VH Operational Data Review | MINUTES

Relevant Test:	Sequence VH
Note Taker:	Chris Mileti
Meeting Date:	12-19-2016
Lubrizol Attendees:	Mileti
Comments:	Operational data review in advance of Sequence VH Precision Matrix. This review focused on transition data.

b) Intake Manifold Absolute Pressure (MAP):

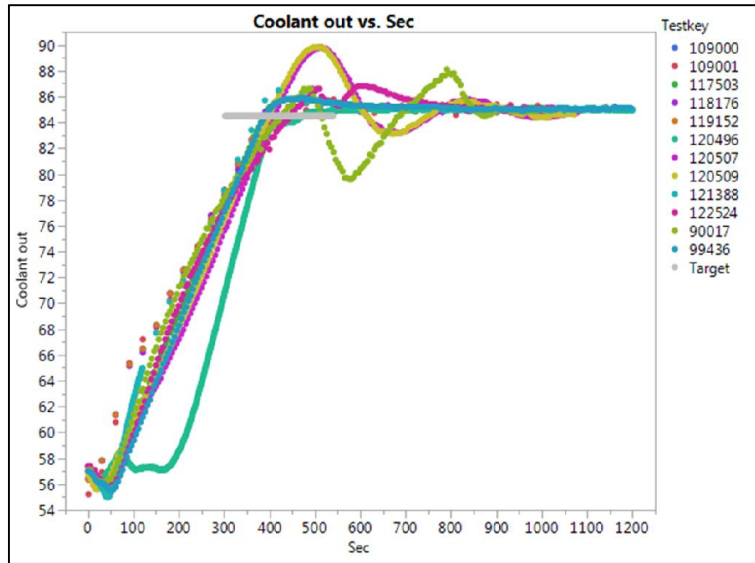
- i) There are drastic differences between labs with the MAP parameter.
- ii) The MAP parameter can be affected by both the speed and load.
- iii) Different labs approach the “window” from different directions.
 - (1) The MAP does not change significantly during the Stage 1→2 transition for some labs.
 - (2) Some labs approach the MAP set-point from relatively high absolute pressures.
 - (3) Some labs approach the MAP set-point from relatively low absolute pressures.

- (1) The differences in MAP control during the Stage 1→2 transition can definitely impact how the PCV valve operates during this time.
- (2) This could, in turn, result in different levels of crankcase evacuation at different labs.

- v) Afton acknowledged that they have the fastest speed ramp.
- vi) The two [blue-green] tests that have the smoothest MAP transition are also the last tests to achieve the speed set-point.

- (1) The VH procedure should be modified to require that the MAP parameter must reach its Stage 2 set-point (66.0 ± 0.2 kPa) within 150-seconds.
- (2) During this time, the MAP measurement must stay within 62-72 kPa.
- (3) Some of the labs will install slave engines to confirm that they can meet these criteria before the start of the Precision Matrix.

c) Coolant Temperature at Outlet:

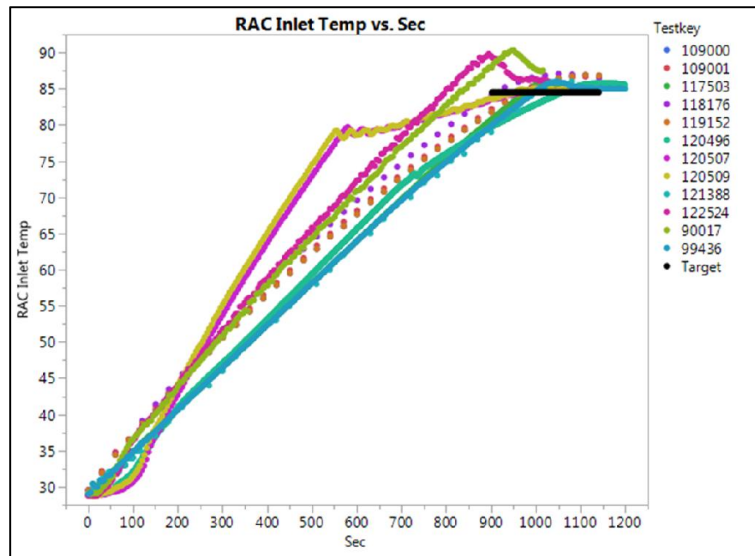
- i) Many of the tests experienced cycling as the coolant temperature approached the set-point.
- ii) Afton has already refined its PID tuning with this parameter.
- iii) Not all of the tests achieve a stable temperature by the end of the time window.
- iv) It may be more difficult to achieve the Stage 2 coolant temperature set-point with this new engine hardware.

a) Power:

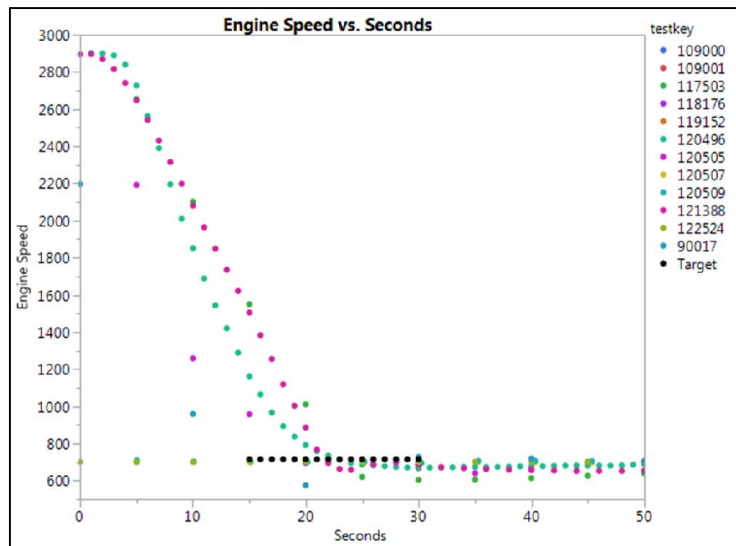
- i) The allowable window of time to hit the power set-point has been adjusted to 15 to 30-seconds.
 - (1) The window for the VG test was 5 to 20-seconds.
- ii) All of the labs should be able to achieve the power set-point within this adjusted window.
- iii) Ashland was able to meet the original window of 5 to 20-seconds.
 - (1) They are now achieving the power set-point too early under the new window.
 - (2) They will slow down their tuning.

b) Speed:

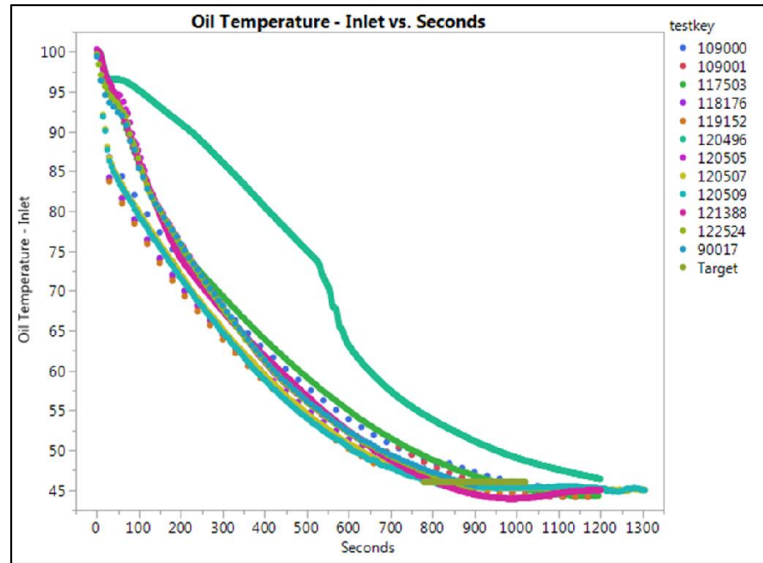
- i) The allowable window of time to hit the speed set-point has been adjusted to 15 to 30-seconds.

c) Oil Temperature at Inlet:

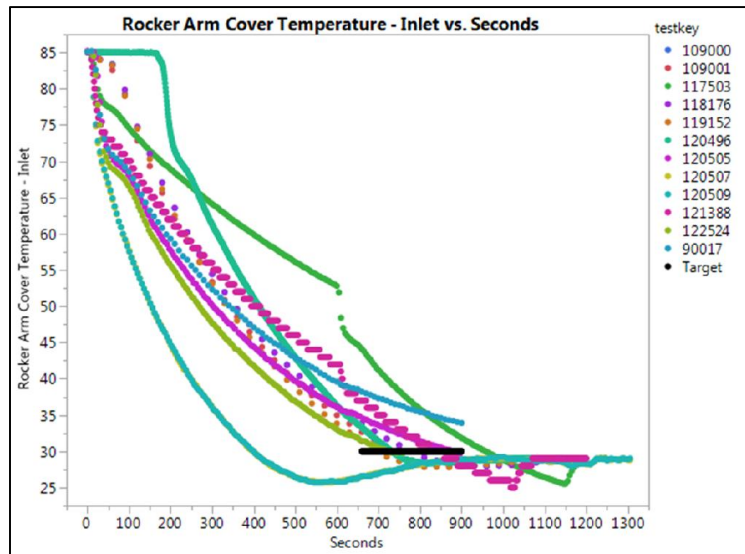
- i) Lubrizol definitely has the slowest oil temperature transition.
- ii) Lubrizol generally overdamps its temperature transitions to prevent cycling around the set-point.
 - (1) As a result, it will be easy to increase the speed of the PID controller to achieve the temperature set-point more quickly.

d) Rocker Arm Cover Coolant Temperature at Inlet:

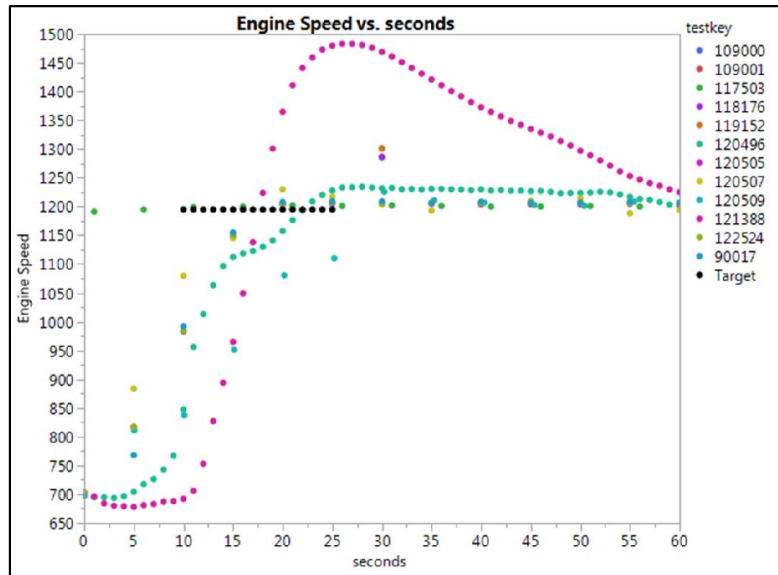
- i) The transitions at some of the labs are slow, while the transitions at other labs are fast.
- ii) All of these differences can likely be addressed through tuning.
- iii) The allowable window of time to hit the rocker arm cover coolant temperature set-point has been adjusted to 13 ± 2 minutes.
 - (1) The window for the VG test was 10 ± 2 minutes.

a) Speed:

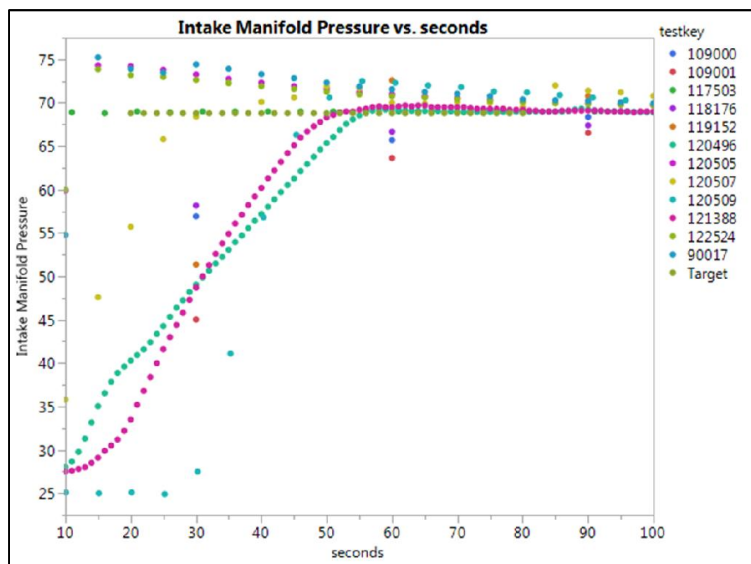
- i) The allowable window of time to hit the speed parameter set-point has been modified.
 - (1) The speed must now be stable around the 1200 ± 5 RPM set-point by 14-seconds.
 - (2) Also, the speed cannot overshoot the set-point by more than 50RPM.
- ii) One of the SWRI tests significantly overshoots the set-point.

b) Intake Manifold Absolute Pressure (MAP):

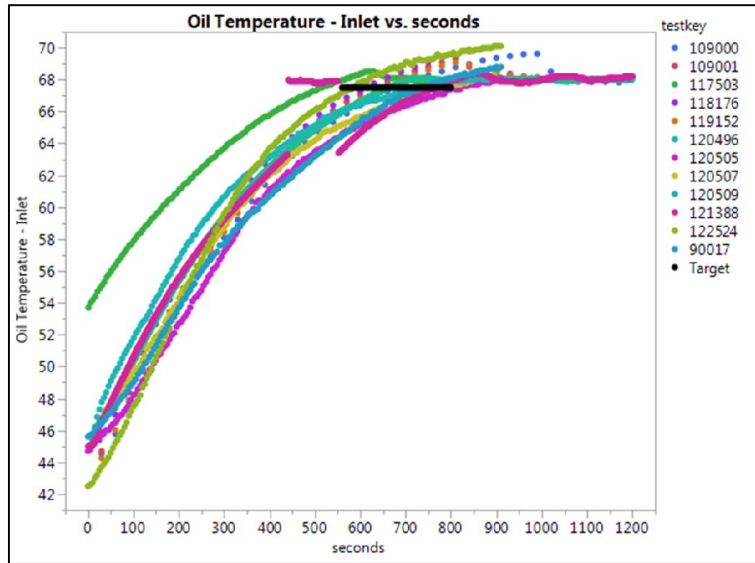
- i) The Stage 1 MAP set-point is 69kPa.
- ii) The MAP data from all of the tests appears to converge around 80-seconds.
- iii) Some labs take too long to hit the set-point while other labs hit the set-point too quickly.
- iv) The group agreed to modify the MAP transition requirements as follows:**
 - (1) The MAP parameter must achieve steady-state conditions at the set point (69.0 ± 0.2 kPa) by 200-seconds.
 - (2) During this time, the MAP parameter is not to exceed 75kPa.

c) Oil Temperature at Inlet:

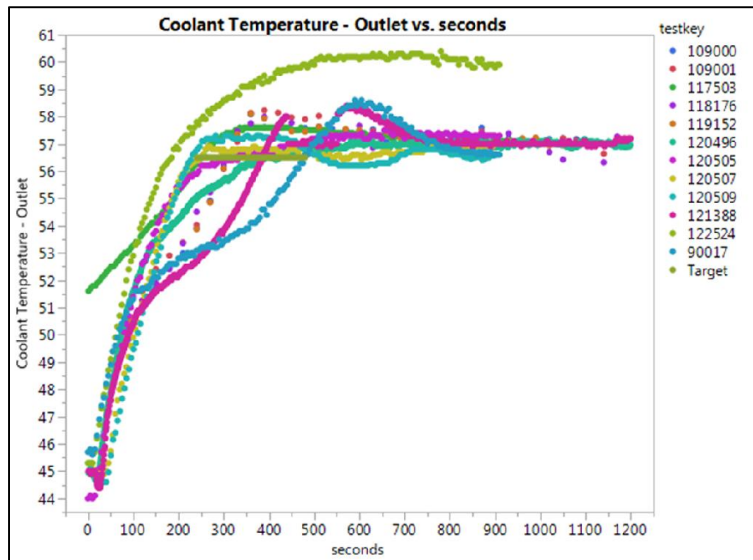
- i) The set-point window has been adjusted so that it is now 560 to 800-seconds.
 - (1) This adjustment was made because one test was slower than the others to reach the set-point.
- ii) One SWRI test (117503) appears to start the transition from the wrong initial temperature.
 - (1) SWRI will confirm that they supplied the correct data set.
 - (2) They will re-submit their transition data to the TMC if needed.
